STAFF RECOMMENDATION
1717 Villa Place
December 18, 2019

Application: Partial Demolition; New Construction—Addition
District: Edgehill Neighborhood Conservation Zoning Overlay
Council District: 17
Base Zoning: RS5
Map and Parcel Number: 10408035900
Applicant: Trent Dabbs, Owner
Project Lead: Sean Alexander, sean.alexander@nashville.gov

<p>Description of Project: The applicant requests to retain an open staircase on the left side of the house that was recently constructed without permits, and to retain a door that was installed in what was originally a window opening.</p> <p>Recommendation Summary: Staff recommends disapproval of the request for after-the-fact approval to retain the exterior staircase and window alteration on the left side of the house at 1717 Villa Place, and that original conditions be returned within 60 days, finding that the work does not meet the following sections of the Edgehill Neighborhood Conservation Zoning Overlay design guidelines:</p> <ul style="list-style-type: none">III.C. Setbacks and Rhythm of SpacingIII.D. MaterialsV.A. Additions (Location and Removability)VI. Demolition (Partial)	<p>Attachments A: Photographs B: Sketch</p>
---	--

1717 Villa Place, front.

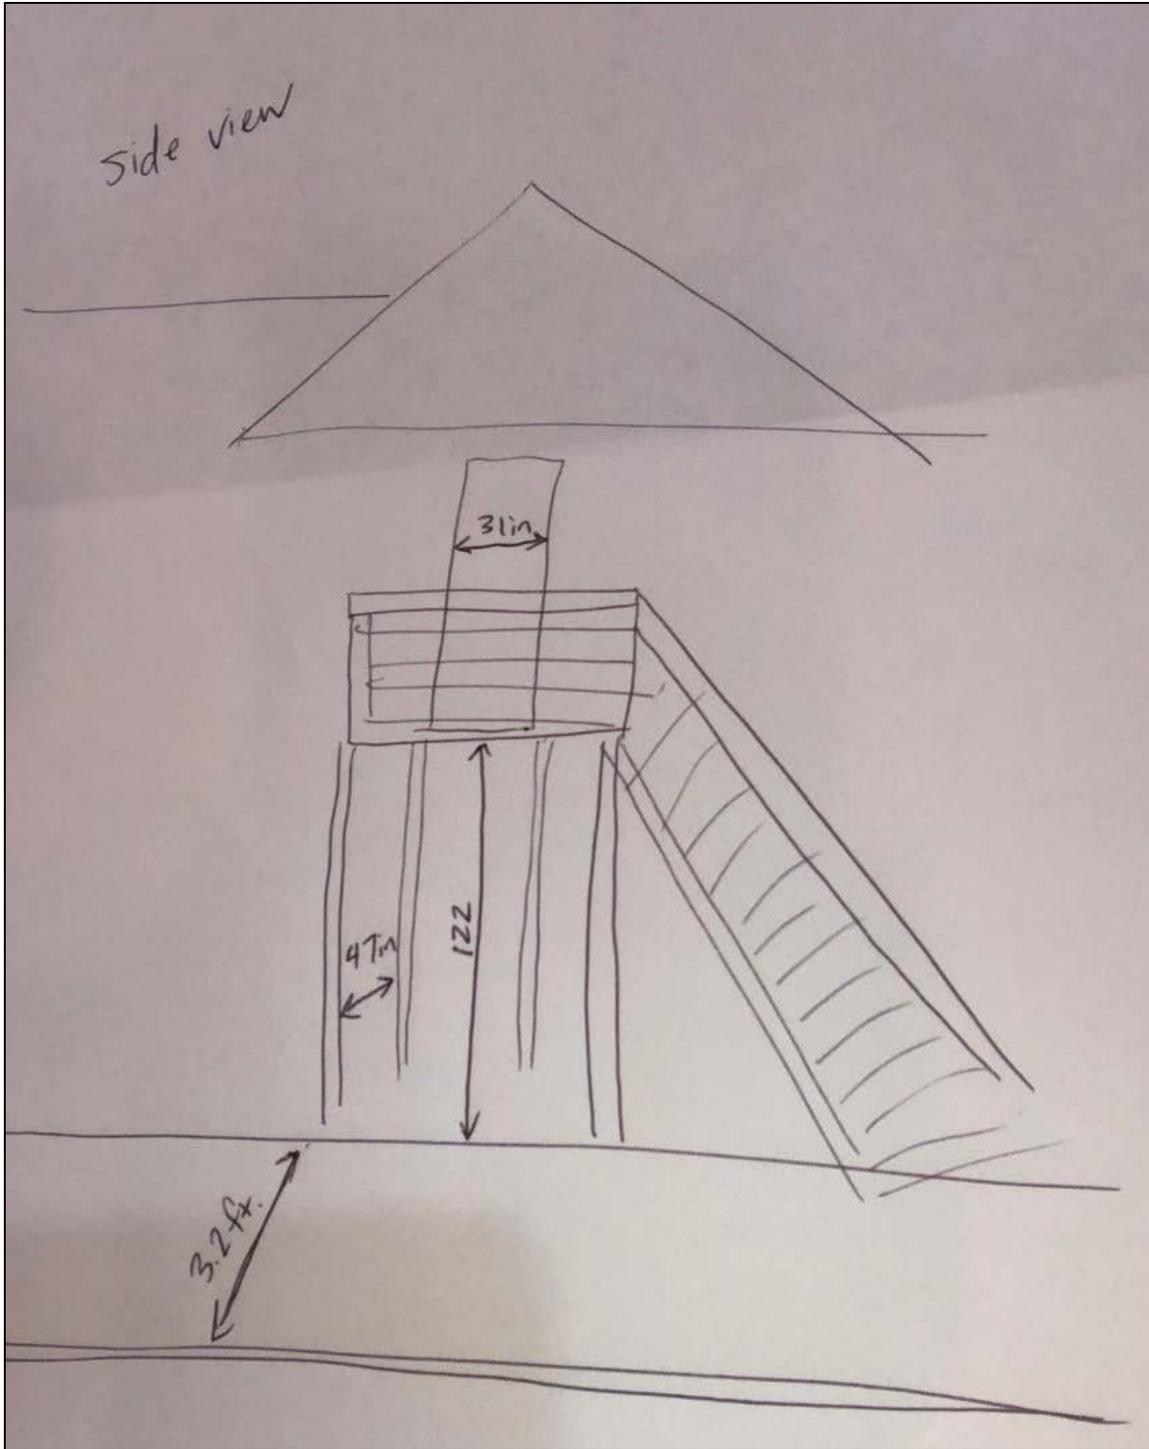
Location & Removability: The new uncovered exterior staircase was added on the left side of the house, originating approximately five feet (5') back from the front wall of the building and leading up to the new door in the center of the gable-field wall. Exterior stairs are not typical of Historic Craftsman style buildings and so are not appropriate unless located on the rear, where they are not visible or are minimally visible.

Additionally, the location of the stair runs across the opening of an original and remaining window opening on the first story. Additions should not disturb side facades or remove or obscure architectural features.

Staff finds that the location and attachment of the stair addition is not appropriate and does not meet Sections V.A, V.B, and V.C. of the Edgehill design guidelines.

Design: The new stairs are wood with solid risers and a wood and steel cable railing, which is relatively modern in design and contrasts with the character of the Craftsman style house. Modern additions are not discouraged when they are compatible with the historic property, do not remove original materials, or are minimally visible. The recently constructed stairs are in a highly visible location, are not consistent with the Craftsman style of the house, and required the removal of a portion of the gable wall.

Staff finds that the stair and window alteration do not meet Section V.A, V.B., IV.C., and IV. F. of the Edgehill design guidelines.

Setback & Rhythm of Spacing: The outside edge of the new staircase is approximately three feet (3') from the left side property line. The standard side setback requirement for stairs with risers is five feet (5'); however, the bulk zoning regulations allow stairs with open risers to encroach into the setback buffer. The applicant is not requesting a setback determination and has agreed to remove the risers in order to meet the setback regulation.

While removing the risers on the stairs would meet the setback requirement, Staff finds that the location of the stairs is not appropriate with the historic context because they alter the appearance of the house and the space between houses.

Staff finds that the stairs do not meet Section III.C. of the Edgehill design guidelines for setback and rhythm of spacing.

Materials: The stairs were constructed of deck grade pressure-treated wood with a railing made of wood and steel cable. The foot of the staircase lands on a poured concrete pad.

These materials have been approved previously as components of an appropriately located rear addition, or for a side or rear entrance on infill, but not on a side addition so near the front of an historic house.

The door that was installed in the gable-field wall is a solid steel panel door, typical of outbuildings or basements but not a primary façade of an historic building.

Although the materials of the stair and door may be appropriate in other applications, Staff finds that they are not appropriate for a highly visible addition on an historic building and therefore do not meet Section III.D. of the Edgehill design guidelines.

Recommendation: Staff recommends disapproval of the request for after-the-fact approval to retain the exterior staircase and window alteration on the left side of the house at 1717 Villa Place and that original conditions be returned within 60 days, finding that the work does not meet the following sections of the Edgehill Neighborhood Conservation Zoning Overlay design guidelines:
